NOTICE OF PUBLIC MEETING

Governmental Body: Van Meter Planning and Zoning Commission

VAN METER, IOWA
HUDSON HEIGHTS PLAT 1
LONG RANGE STREET PLAN

VAN METER, IOWA
TRINDEL RIDGE
PRELIMINARY PLAT
REVIEW COMMENTS

PRELIMINARY PLAT TRINDLE RIDGE

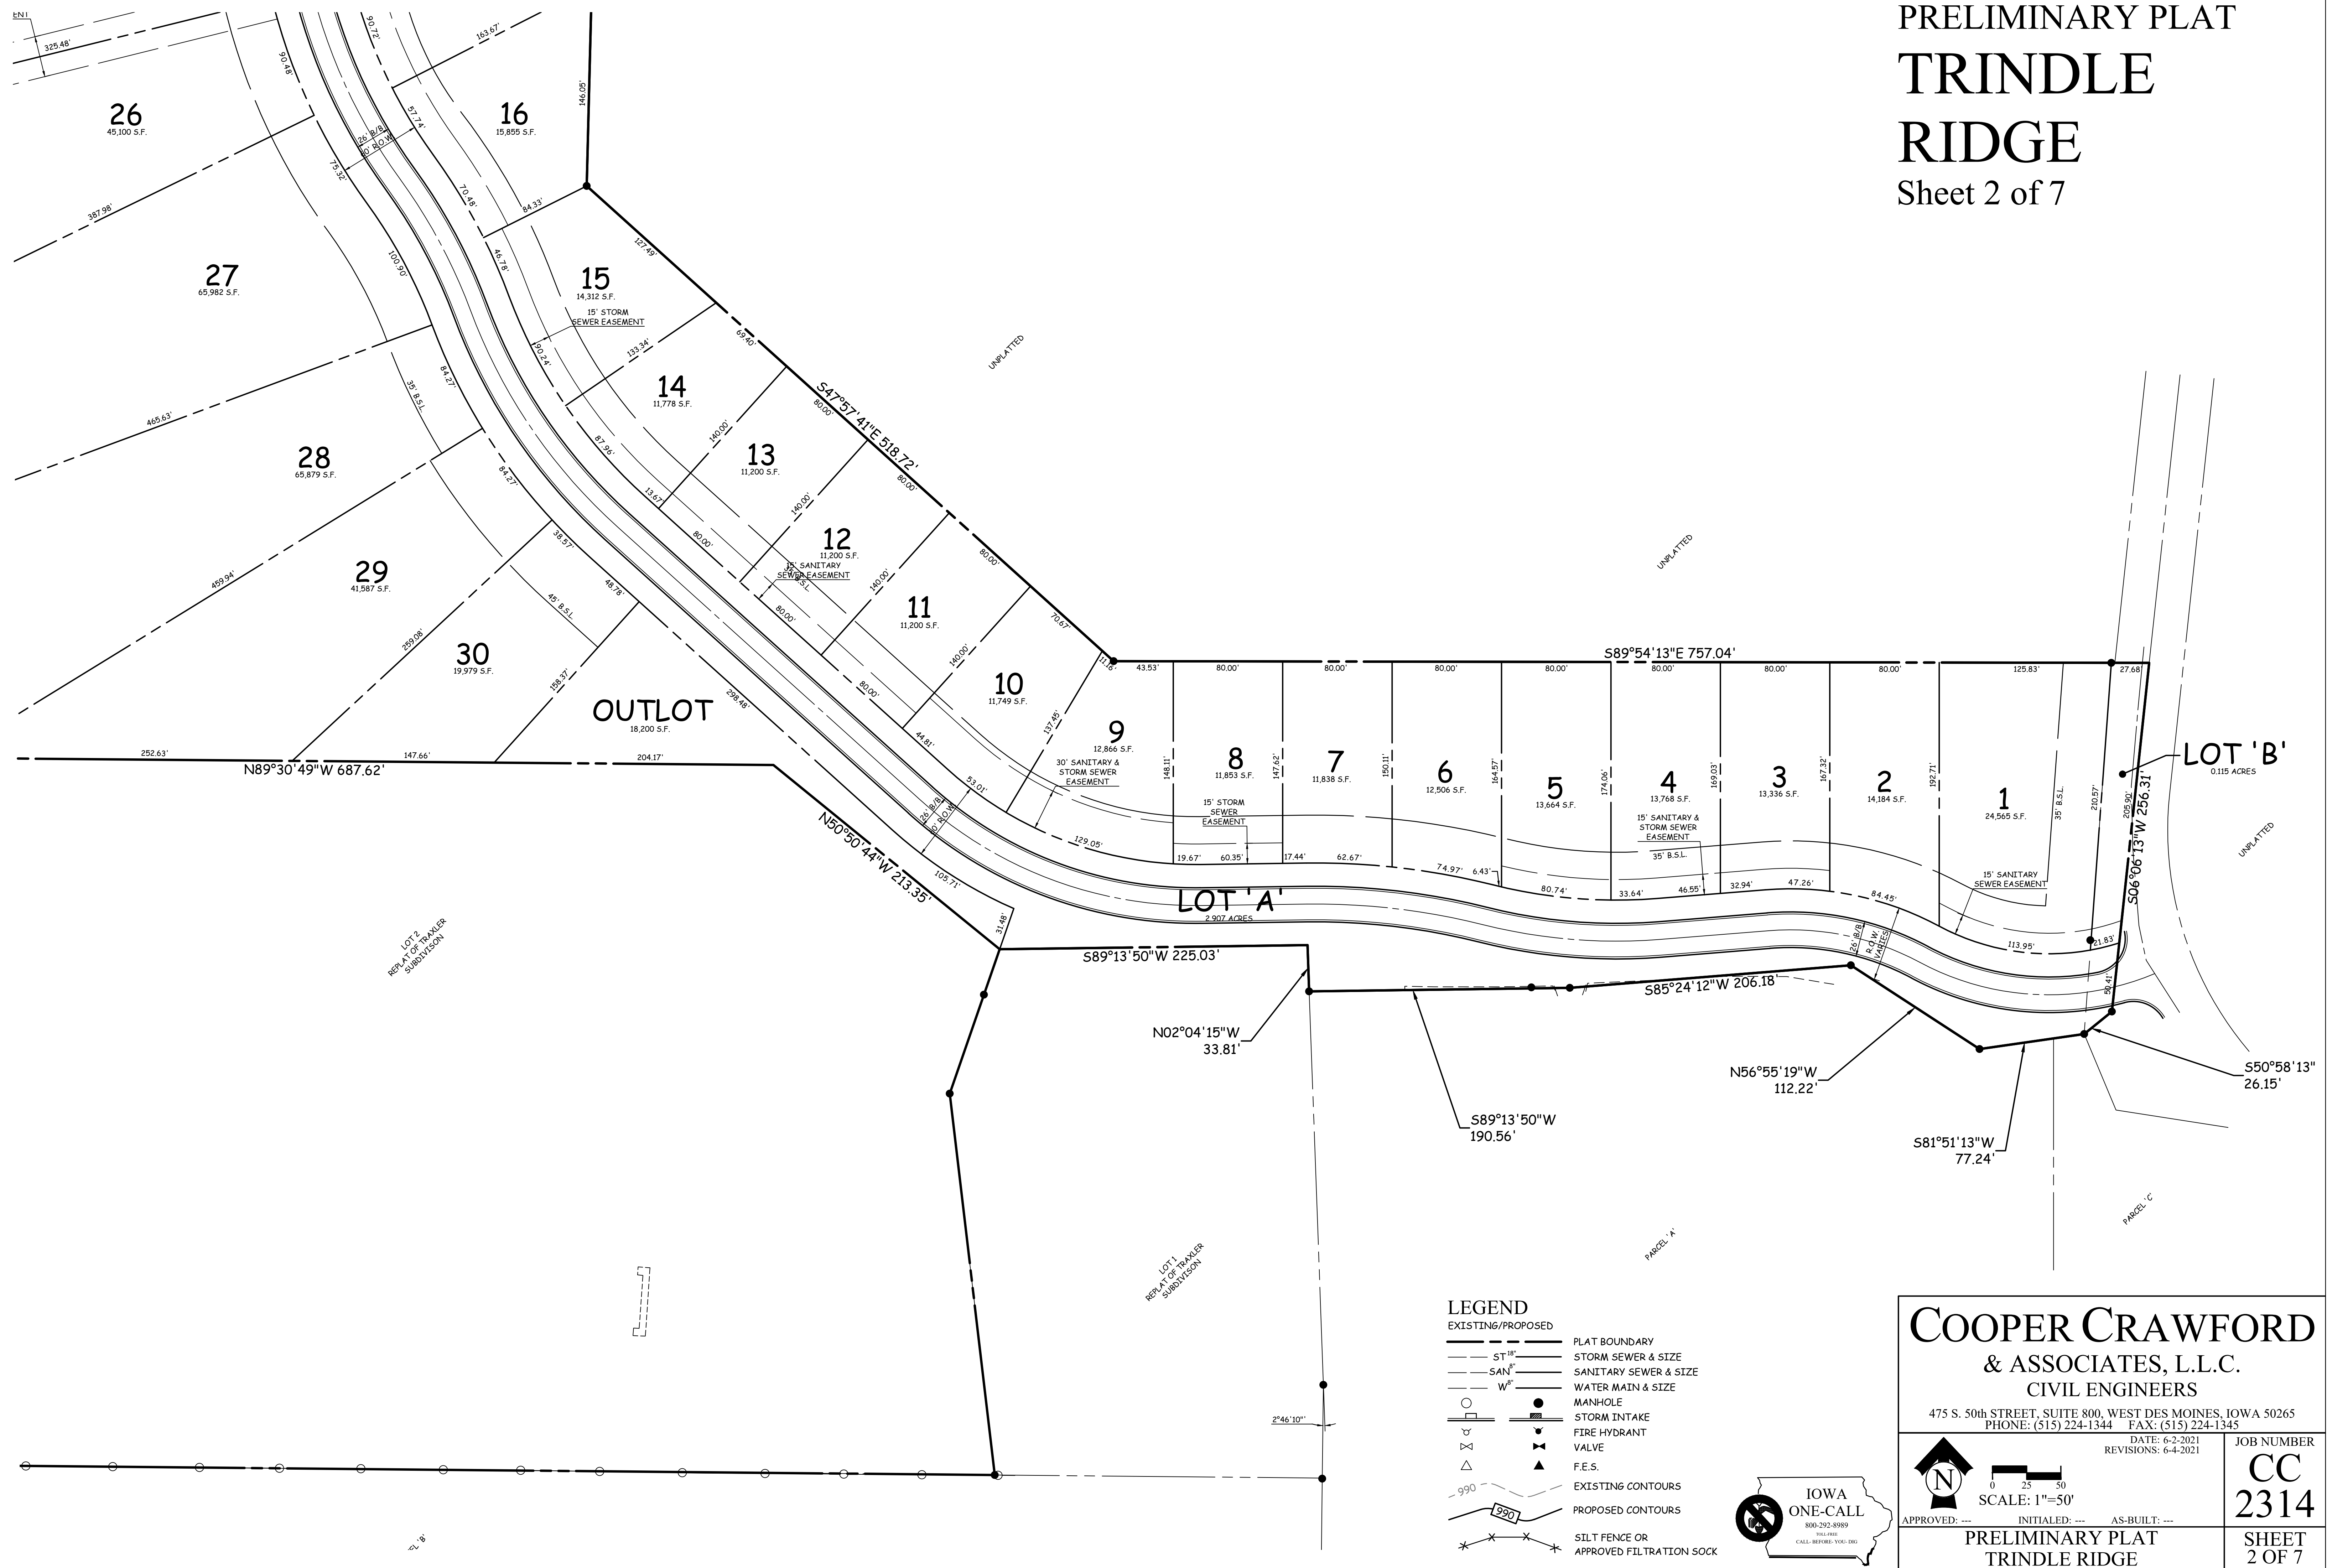
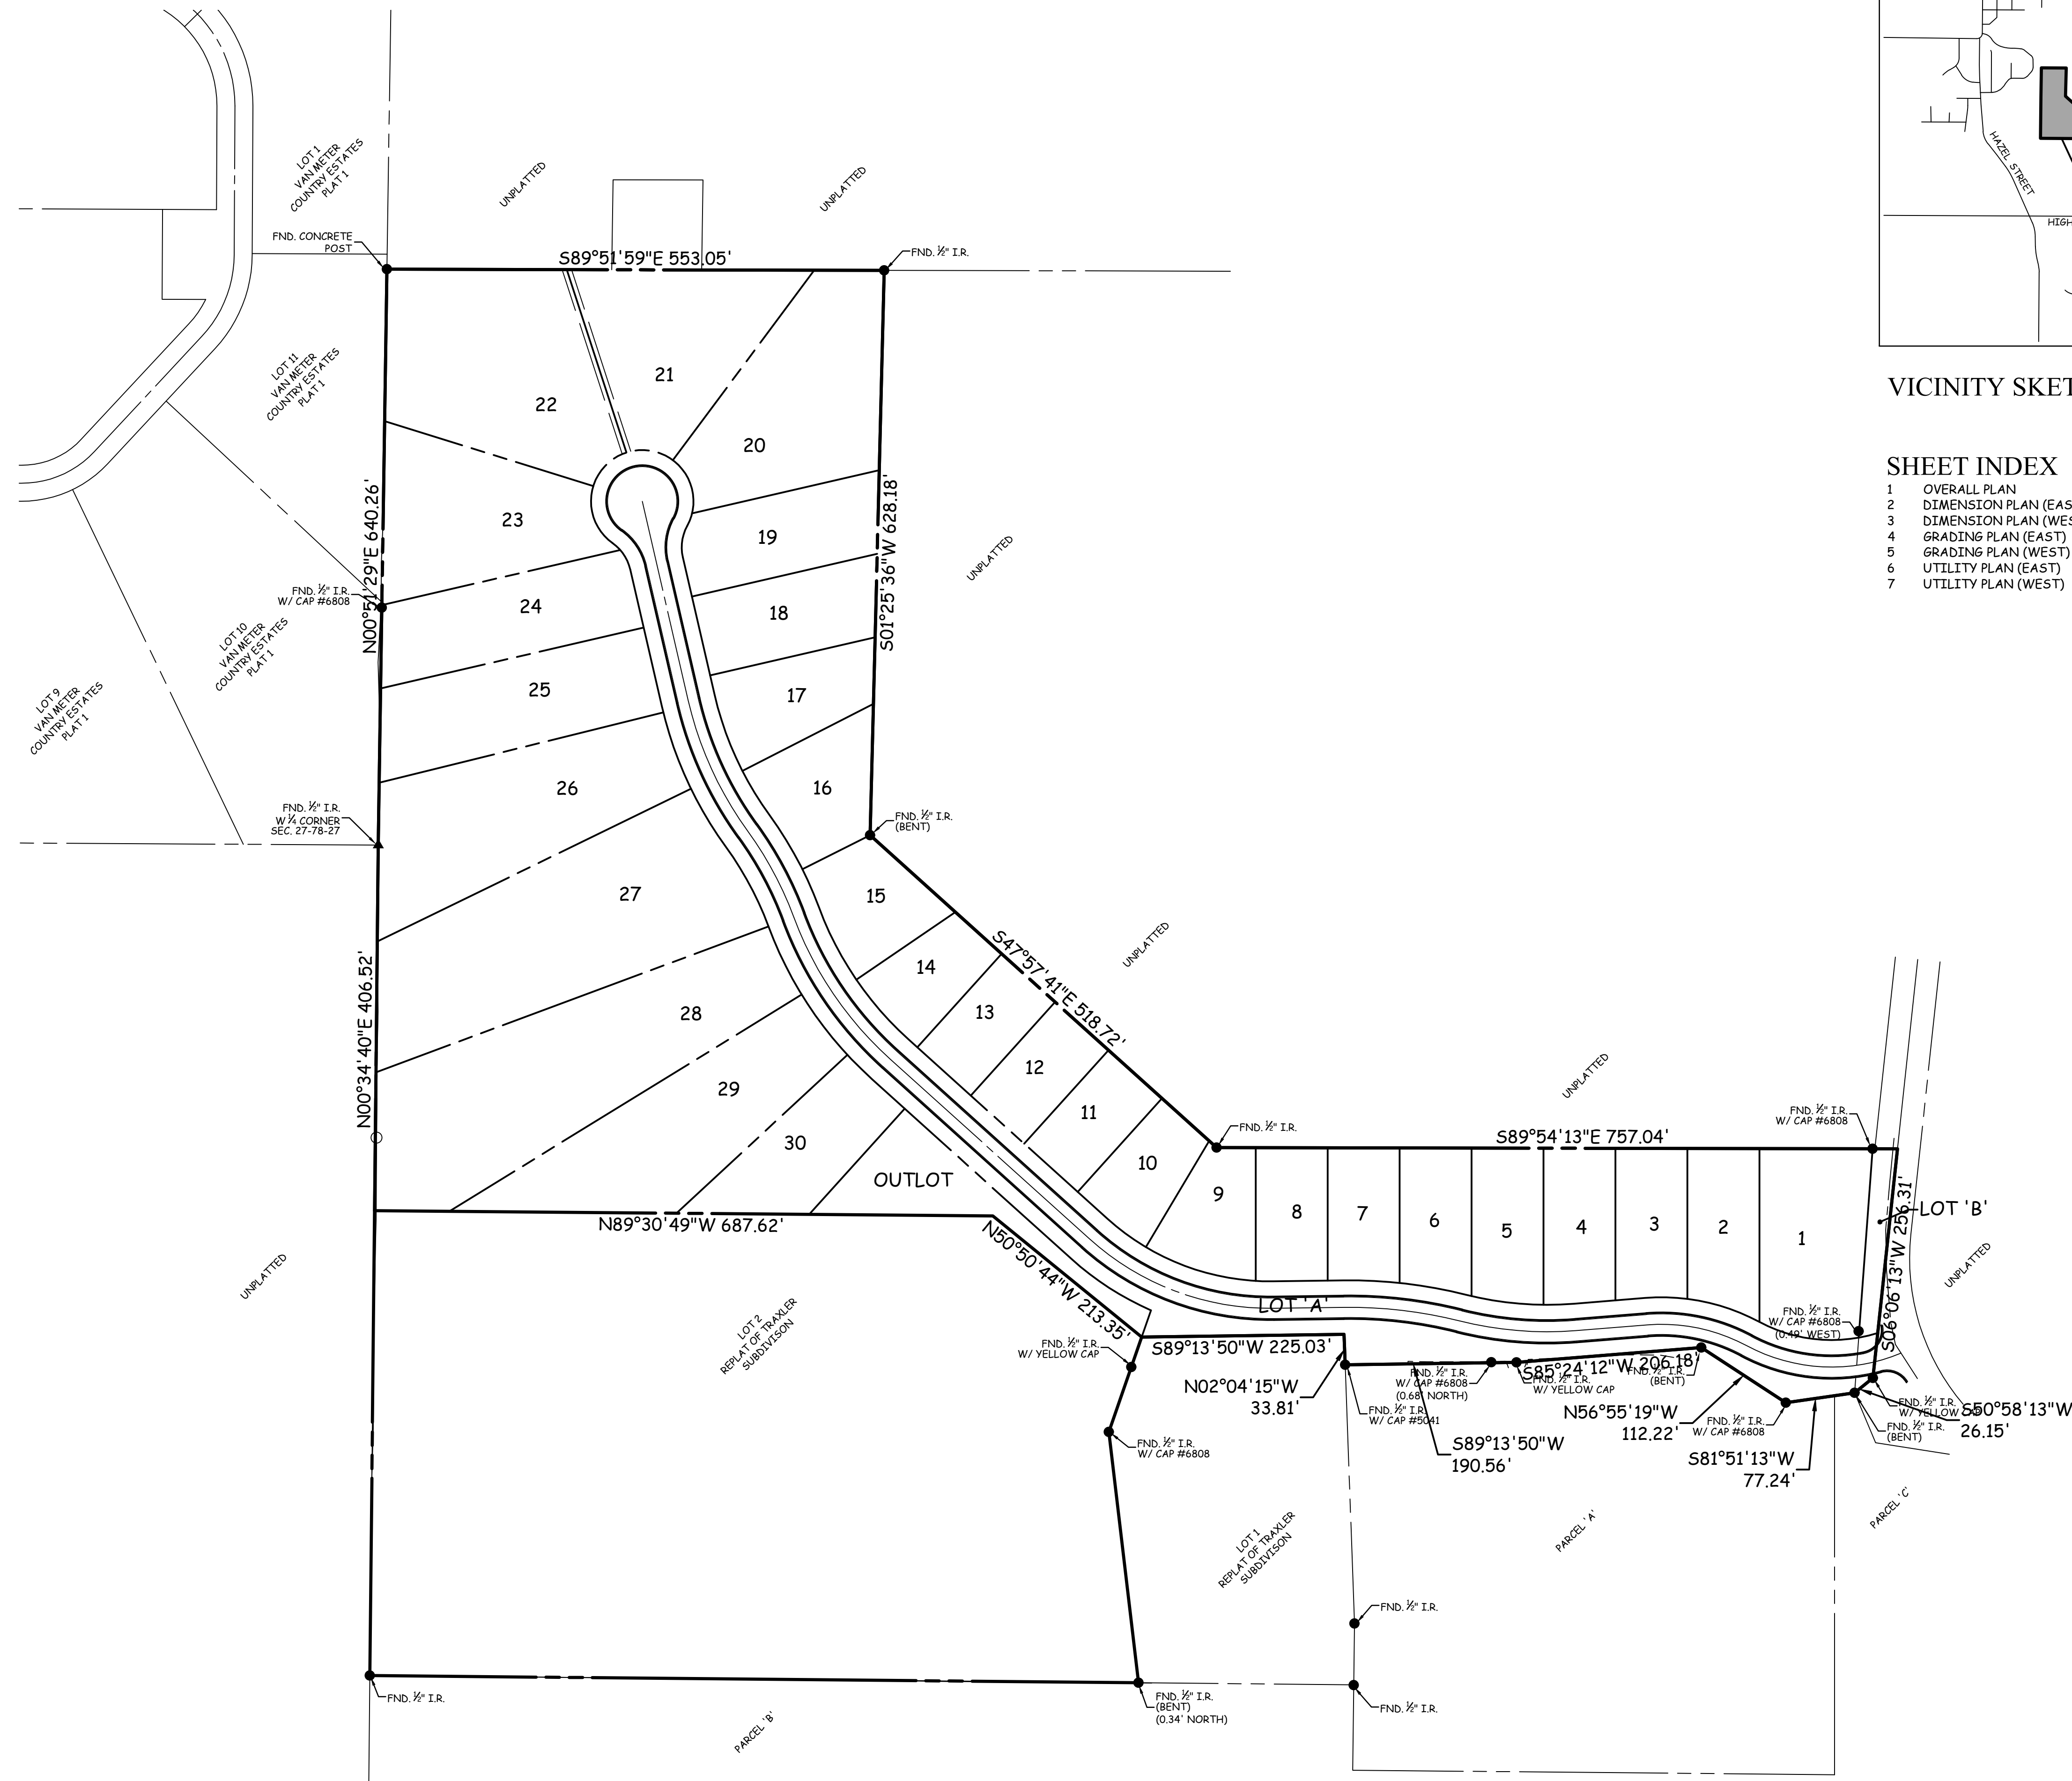
The writer has completed a review of the first submittal of the preliminary plat of Trindel Ridge. Based on review of the preliminary plat the following comments are offered:

1. The project involves 30 single family residential lots, a street lot, and an outlot.
2. The parcel is zoned R1. All of the lots appear to meet the minimum lot area and lot width requirements.

3. The preliminary plat shows a 35-foot front yard building setback line on Lots No. 1 through 28. The front yard setback line meets the requirements of the zoning ordinance.

4. The preliminary plat shows a 45-foot front yard building setback line on Lots No. 29 and 30. The front yard setback line illustrated on the preliminary plat exceeds the minimum requirement of the ordinance. If the final plat shows a building setback line that is greater than required in the ordinance the building setback line on the final plat will govern.

5. It is suggested the preliminary plat show the rear yard and side yard setback lines. For some of the lots, such as Lot No. 15 and 16, the combination of the front yard setback distance and rear yard setback distance limit the area of the lot that is considered developable. While there is still space on the lot for a residence, it would appear preferable for the impact of building setback lines to be shown in the preliminary plat.

6. The preliminary plat shows Outlot A as a street lot. This lot will be dedicated to the City.

7. On Lot No. 1 the eastern part of the lot should be a right-of-way of Richland Circle. The preliminary plat shows what appears to be three property corners that would delineate the eastern part of the lot that should be part of the right-of-way of Richland Circle. It is recommended the portion of Lot No. 1 identified as right-of-way be designated as a street lot and dedicated to the City in fee title. This change does not appear to affect the building setback line as the setback line appears to be drawn from the edge of the way area.

8. The proposed street connects to the existing Richland Circle. The City of Van Meter has previously discussed with the developer its intent to upgrade Richland Circle between Richland Road and the new plat.

9. The preliminary plat shows the proposed street to generally be 26-foot wide street in a 60-foot right-of-way. The ordinance requirement for a "minor" street is 25-foot wide in a 50-foot right-of-way.

10. In the area of Lot No. 2 and Lot No. 3 the right-of-way width is noted as varying and in some areas the right-of-way width on the southerly side of the street would be less than the normal distance of 17 feet between the edge of street and edge of right-of-way. However, it appears the right-of-way is at least 50 feet in width even if it is not symmetrical.

11. The street in Trindel Ridge is a long cul-de-sac. The total length of the cul-de-sac is approximately 1,700 feet and would be in excess of the 600-foot limitation for a cul-de-sac in the subdivision ordinance. However, the topography of the area does not lend itself to the street in Trindel Ridge being interconnected to other portions of the City street network. The City would need to waive the ordinance length limitation in order to approve the plat.

12. The preliminary plat does not show slope of the street. A review of the contours would indicate the street slope is in conformance with SUDAS requirements for residential streets.

13. Sanitary sewer service is provided by a sanitary sewer that starts with a connection to the City constructed offsite sanitary sewer along the lot line between Lot No. 25 and Lot No. 26. The sanitary sewer continues easterly along the lot line to Street Lot A.

14. A sanitary sewer is shown flowing southerly from the cul-de-sac to the sanitary sewer between Lot No. 25 and No. 26.

15. A sanitary sewer is shown flowing northwesterly from Lot No. 1 along Street Lot A to the sanitary sewer between Lot No. 25 and Lot No. 26.
16. No information is provided on the depth, slope or flow line of the sanitary sewer. Review of the sanitary sewer profile will need to await submittal of the construction plans.

17. The existing water main is shown on the preliminary plat. The existing water main is located in the rear yard areas of Lots No. 16 through 20 and crosses to the southerly side of the street between Lot No. 15 and No. 29. The water main continues southeasterly along the southerly side of the street to the area of the Outlot before it leaves the plat area.

18. The preliminary plat shows one hydrant located in the area of Lot No. 11.
19. The preliminary plat must show hydrant coverage circles.
20. Based on the location of the existing water main and no proposed water main the vast majority of the lots will be located outside of the required hydrant coverage.

21. The preliminary plat must address how water service will be provided to all of the lots within the plat.
22. The preliminary plat will need to address a means of providing adequate fire protection. Adequate fire protection may require the construction of additional water main.

23. The preliminary plat shows a storm sewer system located in the eastern part of the development, including a storm sewer outlet to the north on Lot No. 1 and a longitudinal storm sewer from Lot No. 1 to Lot No. 4.

24. A second, and larger, storm sewer system is shown starting with an outlet storm sewer between Lot No. 20 and No. 21. The storm sewer continues southerly and southeasterly along the Street Lot A and terminates near the west boundary of Lot No. 5.

25. The proposed storm sewer would appear to be generally adequate and provides a stormwater service outlet to all of the residences for sump pump discharge.

26. No stormwater detention appears to be proposed as part of the plat development.

27. No stormwater management plan was submitted with the preliminary plat. A more detailed stormwater management plan will need to be provided as part of the construction plans.
28. The grading plan indicates on site grading will generally be provided on the northerly and easterly side of the street encompassing Lots No. 1 through 20.
29. On the westerly side of the street minimal grading is proposed between the street and front yard setback. The majority of the lots on the west side of the street will remain unchanged by development.
30. The grading plan would indicate intent is for the front yards to drain toward the street and the rear yards to drain away from the street toward the plat boundary.
